DART AEROSPACE LTD		Work Order:	136985
Description: Crosstube Assembly, Mid Fwd		Part Number:	D206-667-147
Inspection Dwg: D206-667-147 Rev: A		Page 1 of 2

DART AEROSPACE LTD HAWKESBURY, ONTARIO, CANADA	
DRAWING NO. D206-667-147	REV. A SHEET 1 OF 4
TITLE CROSSTUBE ASS'Y (206L MID FWD)	SCALE NTS
COPYRIGHT © 2010 BY DART AEROSPACE LTD THIS DOCUMENT IS PRIVATE AND CONFIDENTIAL AND IS SUPPLIED ON THE EXPRESS CONDITION THAT IT IS NOT TO BE USED FOR ANY PURPOSE OR COPIED OR COMMUNICATED TO ANY OTHER PERSON WITHOUT THE WRITTEN PERMISSION FROM DART AEROSPACE LTD.

DRAWING NO. D206-667-147	TITLE CROSSTUBE ASS'Y (206L MID FWD)	REV. A	DART AEROSPACE LTD ENGINEERING ORDER		D.E.O. NO. D206-667-147-A-1	SHEET NO. SHEET 1 OF 1	SCALE NTS
DRAWN <i>QD</i>	CHECKED <i>ADS</i>	MFG. APPR. <i>JS</i>	APPROVED <i>MD</i>		DE APPR. <i>MD</i>		
DATE 11.07.15	DATE 11.07.20	DATE 11.07.21	DATE 11/07/21		DATE 11.07.21

DRAWING NO. D206-667-147	TITLE CROSSTUBE ASS'Y (206L MID FWD)	REV. A	DART AEROSPACE LTD ENGINEERING ORDER		D.E.O. NO. D206-667-147-A-2	SHEET NO. SHEET 1 OF 1	SCALE NTS
DRAWN AJS	CHECKED	MFG. APPR.	APPROVED	DE APPR.	DATE 12.08.02	DATE 12.08.02	DATE 12.08.02

DETAIL P
BONDING STRAP INSTALLATION 2 PL

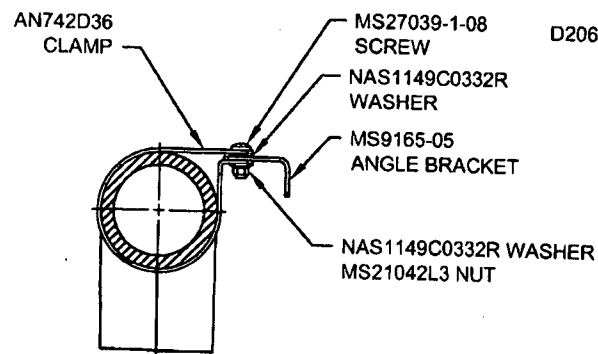
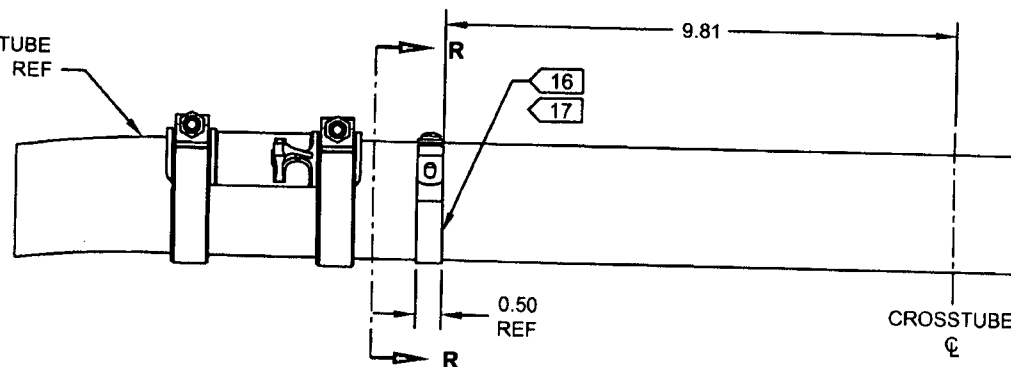
PURPOSE:

ADD ELECTRICAL GROUNDING STRAP

ADD

- 16) MASK AREA UNDER CLAMP PRIOR TO PAINTING
- 17) SEAL EDGES WHERE AN742D36 CLAMP MEETS WITH THE CROSSTUBE USING SIKAFLEX-241/-291 OR MIL-S-8802 CLASS B2 OR PROSEAL 890 SEALANT
- 18) PERFORM RESISTANCE CHECK TO ENSURE MAX RESISTANCE IS 10 MILLIOHMS
